U. S. NUCLEAR REGULATORY COMMISSION
REGION I

REPORT/DOCKET NOS. 50-272/94-80
50-311/94-80

FACILITY: Salem Nuclear Generating Station

INSPECTION DATES: April 8-26, 1994

Figure 1. Pressure Operated Relief Valve

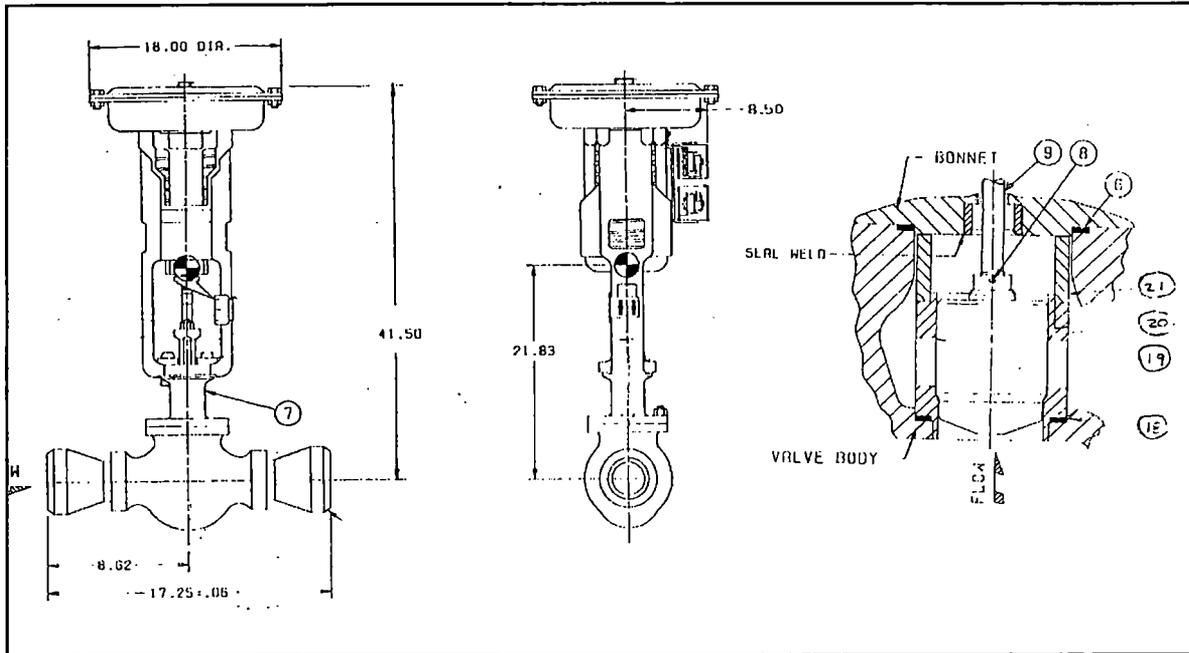
Figure 1 in Attachment 7 shows the Salem PORV design. The valve is air actuated with the actuation diaphragm moving a stem (9) that passes through packing located in the valve bonnet. The stem is threaded into a plug (20) and an anti-rotation pin (8) is driven through the threaded junction to prevent rotation. The bonnet is bolted in place, and holds the cage (19) against a gasket (18) in the bottom of the valve body via the cage spacer (21). The valve seat surfaces are on the bottom of the plug and along the inside of the cage toward the bottom. Lifting the plug moves the plug seat away from the cage seat, allowing flow. At the time of the event for Salem Unit 1, the stem was 316 stainless steel with a chrome plating, the anti-rotation pin was 300 series stainless steel, and the plug and cage were 420 stainless steel. The valves are manufactured by Copes-Vulcan.

The licensee planned to reassemble the internal parts and the bonnet from PR2 in a different valve body and test to destruction with water at ~ 2300 psi if a test facility can be found that will use the radioactive components. The internal parts from PR1 will be carefully examined. The licensee will examine new internal parts for the PORVs to see if there are cracks in the vicinity of the anti-rotation pins.

Figure 2. Reactor Coolant System Pressure

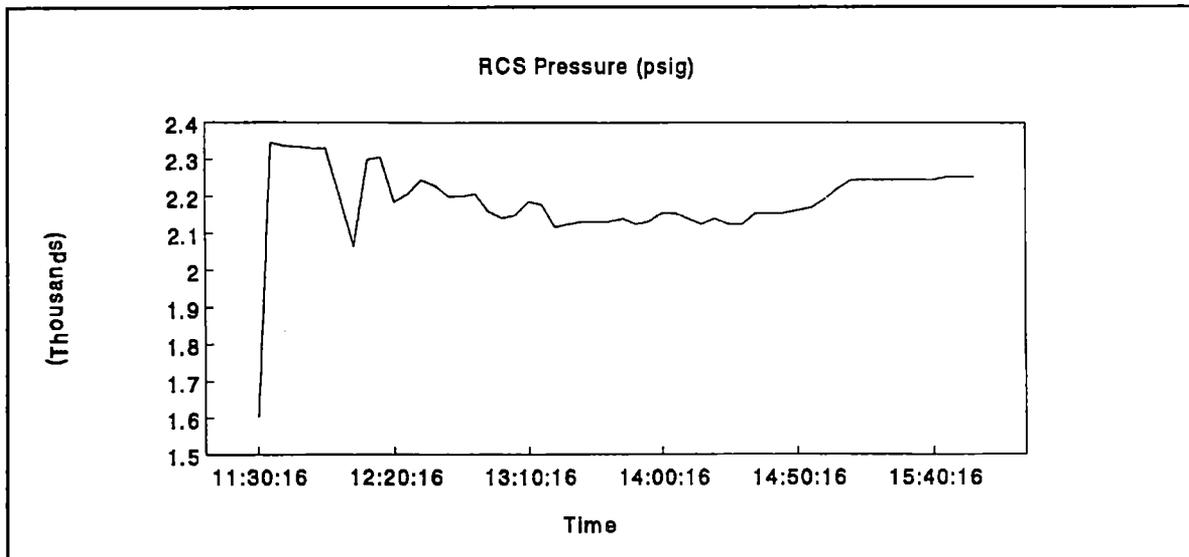
The PORVs actuated over 300 times during the event to relieve water and successfully prevented an RCS overpressure condition. Figure 2 in Attachment 7 depicts the RCS pressure during the transient after the second SI actuation. It was during the period from about 11:30 a.m. to 12:00 noon that the PORVs experienced the greatest amount of operation.
